SERVICE-INFO

Citroen/Peugeot 2.0 Litre 135bhp RepSet & DMF clarification

Manufacturer:
Citroen
Peugeot

LuK AS Part No:
415 0225 10
415 0320 10

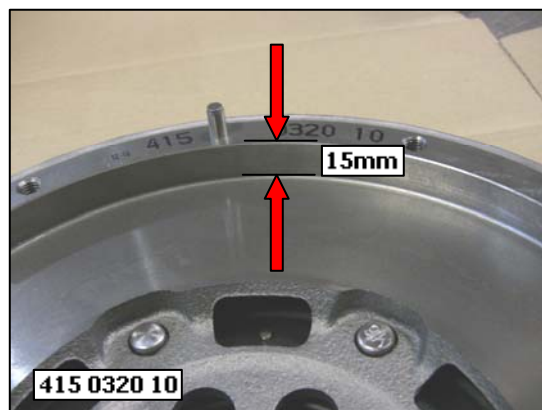
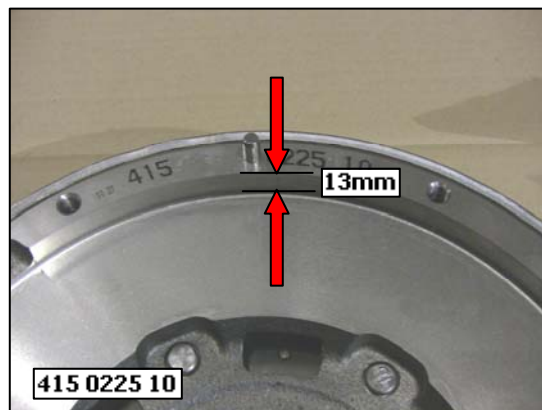
This bulletin is to clarify the catalogue listing for the above vehicles and the compatibility between RepSet and Dual Mass Flywheel. DMF part number 415 0225 10 with RepSet 624 3231 00 is fitted to vehicles built prior to Sep 2006. For vehicles built after October 2006, DMF part number 415 0320 10 and RepSet 624 3267 00 must be used. As not all VRM databases show accurate build dates this may cause compatibility issues if only the RepSet is required.

The difference between the two DMF's is the pot depth as shown above, therefore if the incorrect RepSet is fitted then the clutch will not operate correctly.
